Transportation Impact Assessment

PROPOSED GAS STATION DEVELOPMENT

8605 Campeau Drive, City of Ottawa

**Re: Transportation Impact Assessment - Addendum
Proposed Gas Station Development
8605 Campeau Drive, City of Ottawa
Our Project No. NT-20-091**

Appendix A - Proposed Site Plan

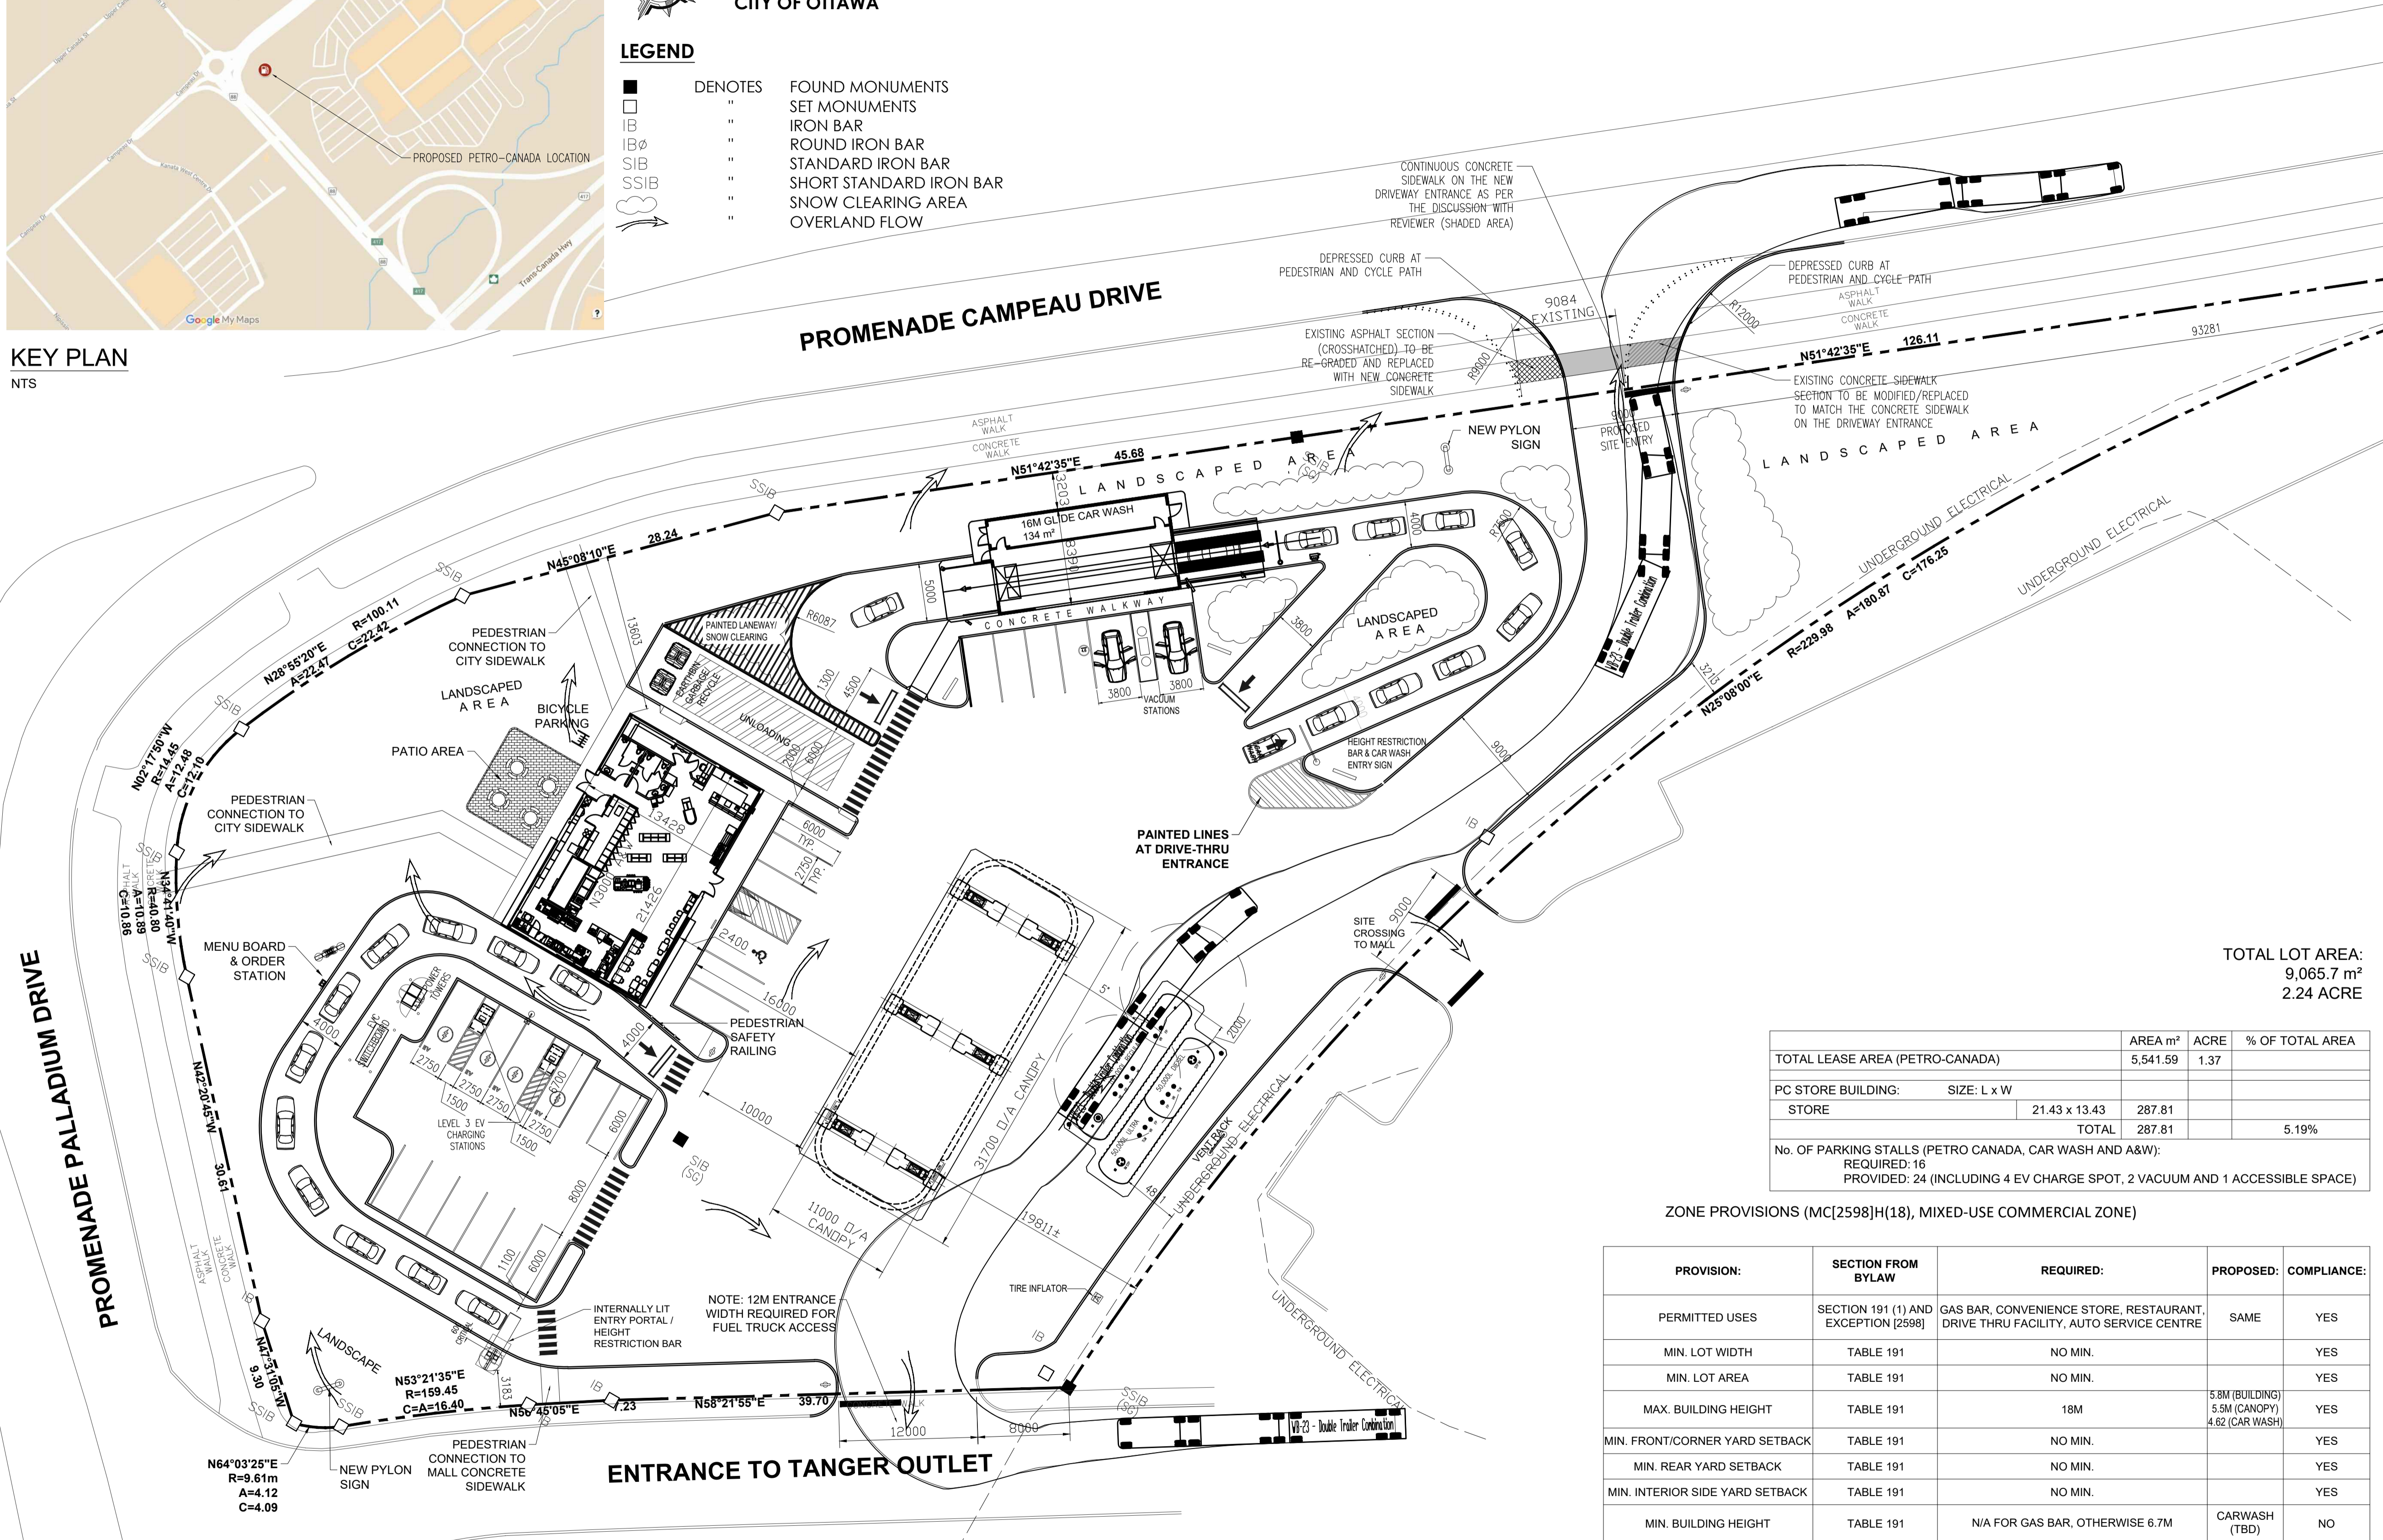
- 2.1. *The Campeau access must have the cycle track and sidewalk be continuous and depressed (TWSIs).*

Response: Acknowledged. Site plan will be revised.

The updated site plan dated February 8, 2023 has been appended to this report. The development proposal consists of a gas station comprising of six (6) gasoline pumps with 12 fueling stations, a car wash, and a convenience store and eating establishment with a drive through

REVISION	
1	2023-02-08 ADDED LEVEL 3 EV CHARGERS, SHOWING LG ELECTRICAL LINES, SHIFTING LG TANKS, SHOWING DEPRESSED CURBS AT CYCLE/PEDESTRIAN CROSSING
